BELLEFONTE COMBINED LICENSE APPLICATION – RESPONSE TO REQUEST FOR  
ADDITIONAL INFORMATION – ATMOSPHERIC DISPERSION ESTIMATES FOR  
ROUTINE RELEASES

Reference: Letter from Joseph Sebrosky (NRC) to Andrea L Sterdis (TVA), Request for  
Additional Information Letter No. 140 Related to SRP Section 02.03.05 for the  
Bellefonte Units 3 and 4 Combined License Application, dated December 9, 2008

Subject: Atmospheric Dispersion Estimates for Routine Releases in the Final Safety Analysis  
Report

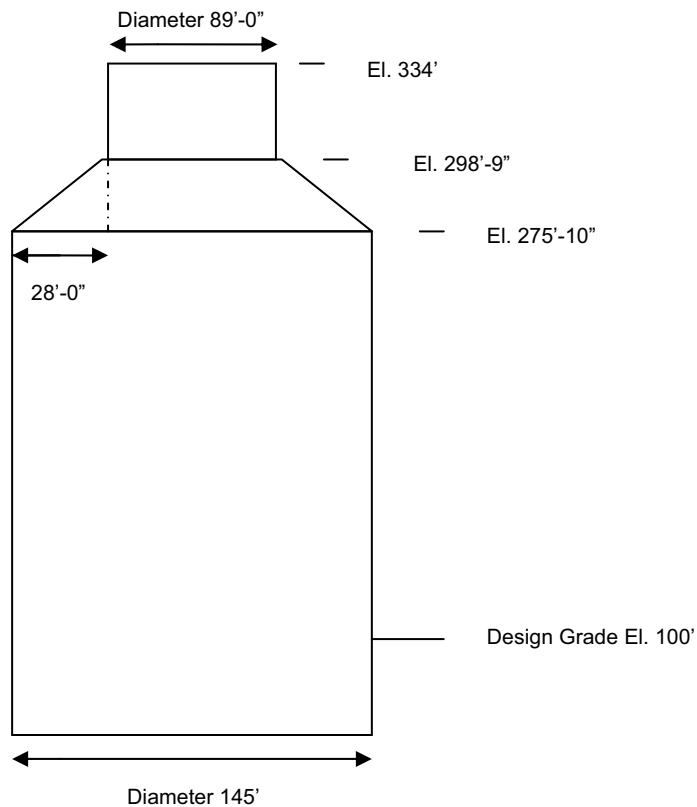
With regard to the XOQDOQ computer code card type 16 inputs, where are the AP1000-specific values documented?

The dimensions from Table 3.3-1 of the AP1000 DCD, Rev. 15, Tier 1 Material and a Westinghouse drawing, which were used in the analysis are:

Design Plant Grade – El. 100'-0"

Distance from Design Plant Grade to Top Surface of Shield Building Roof – 234'-0"

Outside Surface of Shield Building Wall to Shield Building Centerline – 72'-6"

Elevation Range of Shield Building Conical Roof – 275'-10" to 298'-9"

PCS Tank Roof – El. 334'

PCS Water Storage Tank Outside Diameter – 89'-0"

These elevations and dimensions are used to create the diagram of the shield building cross-section below.

Above Grade Cylindrical Section:

$$\text{Width} = 2 \times (72' - 6") = 145' - 0" = 145.0 \text{ ft}$$

$$\text{Height} = (275' - 10") - (100' - 0") = 175' - 10" = 175.83 \text{ ft}$$

$$\text{Area} = 145.0 \times 175.83 = 25495.4 \text{ ft}^2 = 2369 \text{ m}^2$$

Conical Roof:

$$\begin{aligned} \text{Area} &= [(298'-9'') - (275'-10'')] \times [(89'-0'') + (28'-0'')] \\ &= 2681 \text{ ft}^2 = 249 \text{ m}^2 \end{aligned}$$

PCCS Tank:

$$\begin{aligned} \text{Area} &= [(334'-0'') - (298'-9'')] \times (89'-0'') \\ &= 3137 \text{ ft}^2 = 291 \text{ m}^2 \end{aligned}$$

**Total Area = 2909 m<sup>2</sup>**

Example for Calculating Distances

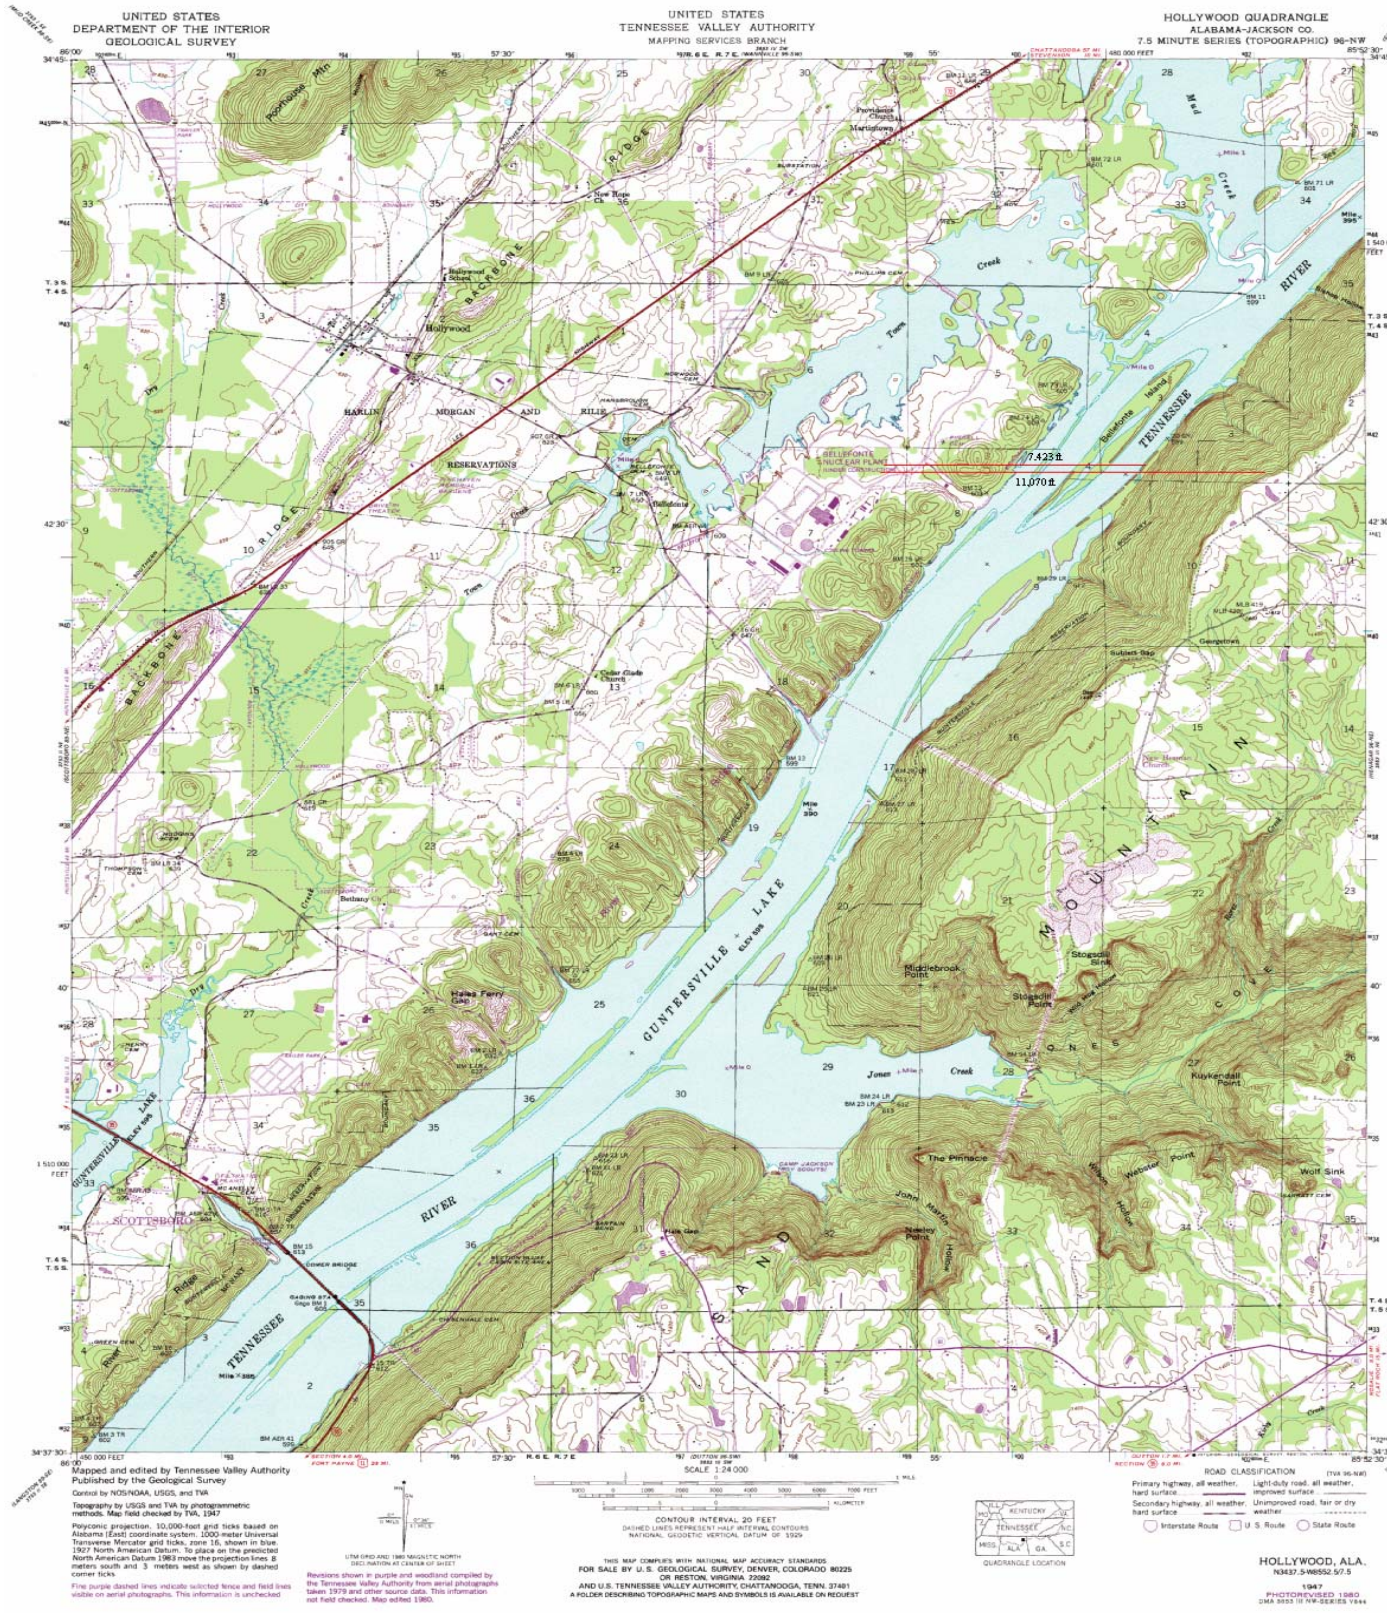
Were the XOQDOQ computer code input terrain distances and heights, card types 10 and 11, derived from either Bellefonte FSAR Figure 2.3-286 or 287? Why were the first set of heights for all 16 sectors input as zeroes? Please provide a figure or figures marked to show several examples of how the distance and height inputs were derived.

The terrain distances and heights (XOQDOQ Card Types 10 and 11) were developed using topographical maps of the area. The points of significant elevation increases for each directional sector were identified on the maps and the distances were approximated using the drawing scales. The minimum distances to a significant elevation change within a 45° sector centered on each of the 16 directions were used. The first set of heights is all zeroes because the first set identifies the starting point for the elevation changes. The terrain is relatively flat from the site to the distances identified as the starting points for the significant elevation changes. There are elevation increases of up to approximately 150 ft on the east side of the plant before crossing the Tennessee River. However, these elevation changes are insignificant compared to the increases of approximately 800 ft. on the opposite side of the Tennessee River. An example is provided in Attachment 02.03.05-007A. Refer to response to RAI 02.03.05-003 (BLN-RAI-LTR-095) for further details.

The following figure provides an example for determining the approximate distances and heights of significant elevation changes near the Bellefonte site.

The example shows the “distance to the beginning of the incline” of 7,423 ft and the “distance to peak” of 11,070 ft for the East direction from the Bellefonte site. These distances were previously provided in response to NRC RAI 02.03.05-03 (BLR-RAI-LTR-095).
